Draft submission to, amendments to SEPP (Western Sydney Aerotropolis) 2020, Open Space Needs Study, draft Aerotropolis Development Control Plan - Phase 2 and Luddenham Village Discussion Paper

Proposed amendments to SEPP (Western Sydney Aerotropolis) 2020

Draft Aerotropolis Development Control Plan Phase 2

Map 1 Undevelopable Parcels due to location of Stormwater Infrastructure

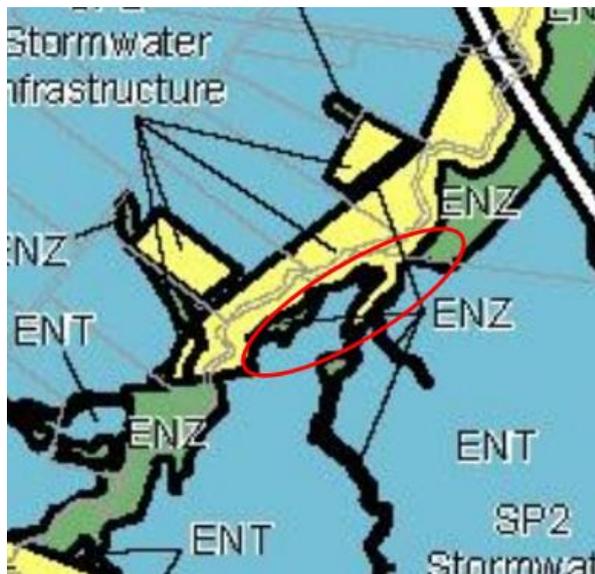
Due to the revision of the open space network, there are several parcels of land in the Northern Gateway Precinct that were previously identified as open space in the Aerotropolis Precinct Plan, and that are zoned Enterprise, that do not meet the minimum block size control of 150m x 150m of the Aerotropolis Precinct Plan due to the location of stormwater infrastructure and rendering these properties not being able to be developed.

The following map highlights the parcels that cannot be developed and the adjoining SP2 Stormwater Infrastructure Zone and the Land Reservation Acquisition affectation should also apply to these parcels of lands.

Land management of these parcels of land will be an issue if they remain in private ownership.
